Technical Service Bulletin

SUBJECT:			No: TSB-13-42A-002
DOOR ADJUSTMENT UPDATE FOR VEHICLES WITH SIDE SRS – SERVICE MANUAL REVISION			DATE: January, 2013
			MODEL: See below
CIRCULATE TO:	<input type="checkbox"/> GENERAL MANAGER	<input type="checkbox"/> PARTS MANAGER	<input checked="" type="checkbox"/> TECHNICIAN
<input checked="" type="checkbox"/> SERVICE ADVISOR	<input checked="" type="checkbox"/> SERVICE MANAGER	<input type="checkbox"/> WARRANTY PROCESSOR	<input type="checkbox"/> SALES MANAGER

This Technical Service Bulletin updates the door adjustment procedure in the Body Section of the applicable service manuals.

<NEW>
DOOR

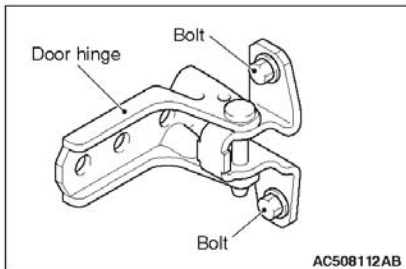
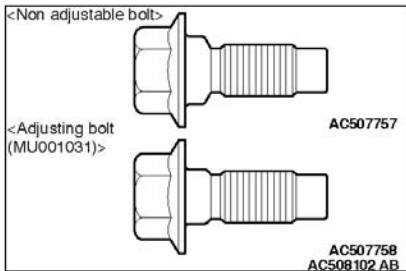
Please replace the door adjustment procedure with the provided information:

To avoid inadvertent airbag deployment, always turn ignition switch to the "OFF" position and wait 60 seconds or more before adjusting the striker.

- (4) Use the door hinge adjusting wrench (Special tool: MB990834 or MB991163) to loosen the body-side door hinge mounting bolts (mounting nuts for the door upper hinge of the rear door).
- (5) Move the door to adjust the clearance between the door and the body is even.

To adjust the striker, always turn the ignition switch to "LOCK" (OFF).

3. When the door is stiff to close and open:

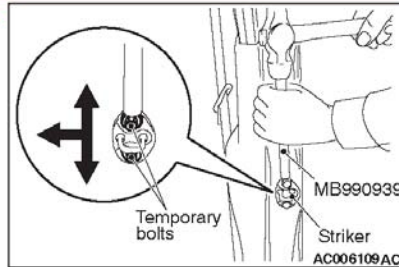
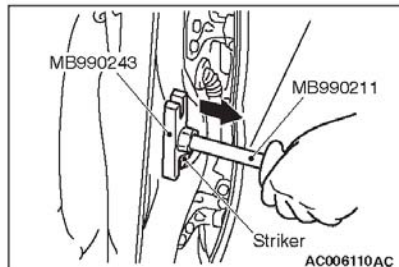
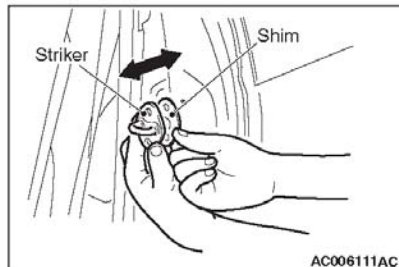
- (1) Adjustment using the striker (toward the inside of the vehicle and vertical direction):
Install a temporary bolt instead of the striker mounting bolt, and use the remover bar (Special tool: MB990939) and a hammer to tap the temporary bolt to the desired direction.

- (2) Adjustment by using the striker (toward the outside of the vehicle):
Using the following tools, pull the striker toward the outside of the vehicle to adjust.

- Slide hammer (MB990211)
- Body puller (MB990243)

- (3) Adjustment using shims: (forward and rearward)
Increase or decrease the number of shims so that the striker engages with the door latch properly.
